**CITY COUNCIL AGENDA
MONDAY, JUNE 15, 2020
250 NORTH 5TH STREET
6:00 PM – SPECIAL MEETING – CITY HALL AUDITORIUM**

Item #1.a.i.

A Resolution Accepting the Petition for Annexation of 45.543-Acres of Land and Ordinances Annexing and Zoning the Magnus Court Annexation to PD (Planned Development) for Two (2) Properties and An Ordinance Rezoning Two (2) Properties from R-E (Residential Estate) and R-2 (Residential – 2 Dwelling Units Per Acre) to PD (Planned Development) with an Outline Development Plan Called Magnus Court to Develop 74 Single-Family Detached Lots with an R-2 (Residential – 2 du/ac) Default Zone District. The Properties Combined are 69.67 Acres and are Generally Located at the West End of Magnus Court and Include the Property Addressed as 2215 Magnus Court #A - [Staff Presentation](#) and [Applicant Presentation](#)

Figure 15: Design Year Total Traffic (2040) (35% NB, 65% SB)

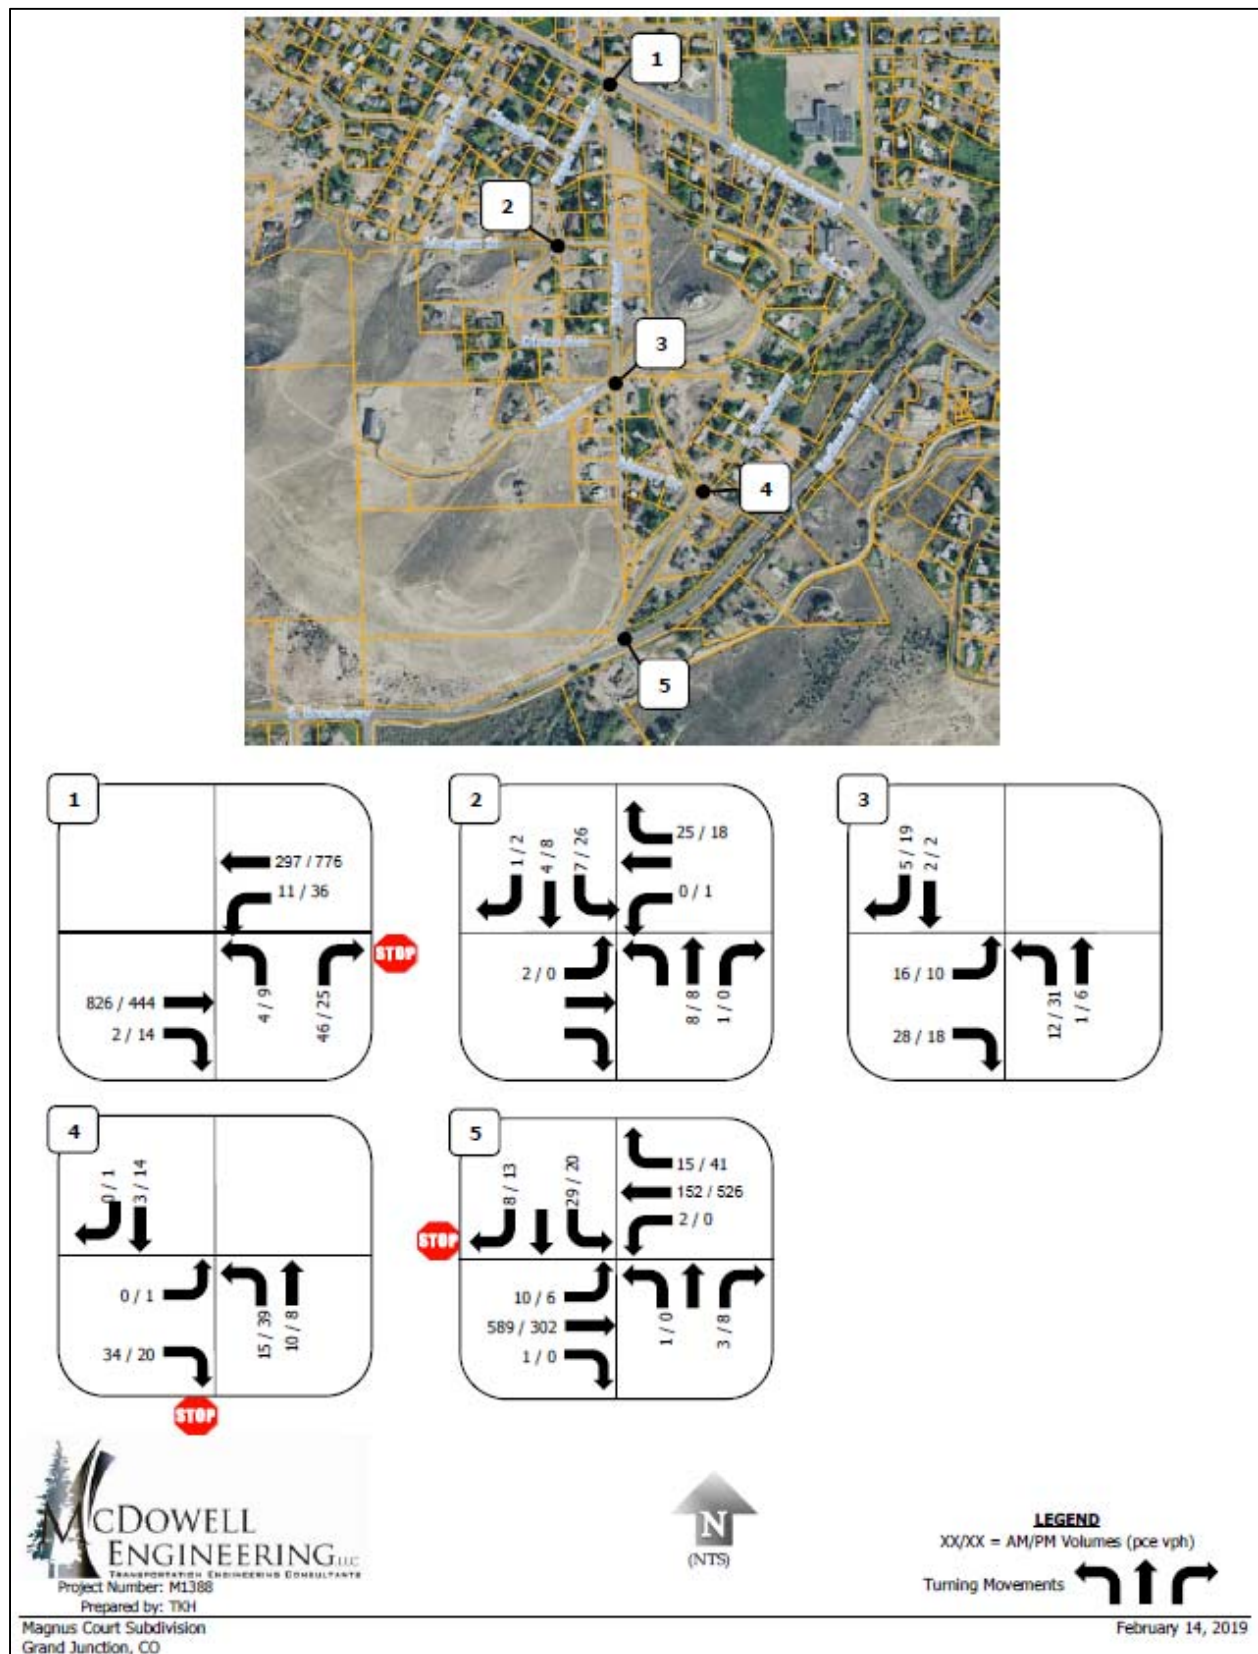
3. It appears that the numbers used in the 2040 BG AM analysis don't match those shown in Figure 15. **The numbers used in the 2040 BG AM analysis should be from Figure 6.**

Figure 15A: Design Year Total Traffic (2040) (15 % NB, 85 % SB)

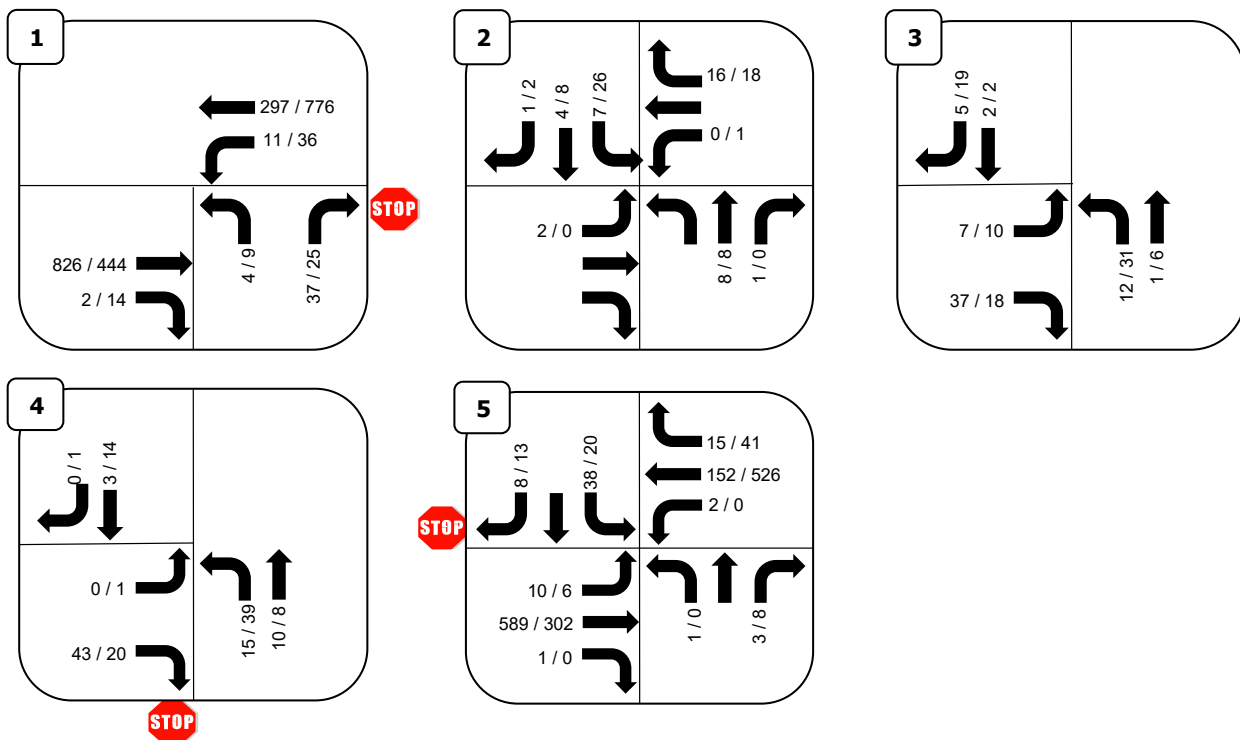
A new scenario was analyzed with northbound traffic reduced to 15% during the morning peak hour. The resultant trip distribution percentages and site-generated traffic volumes are shown in Figure 7A and Figure 9A, respectively. When the site-generated traffic is added to the initial background volumes from Figure 5 in the TIS, the initial year total traffic is shown in Figure 13A. When the site-generated traffic is added to the design year background volumes from Figure 6 in the TIS, the design year total traffic is shown in Figure 15A.
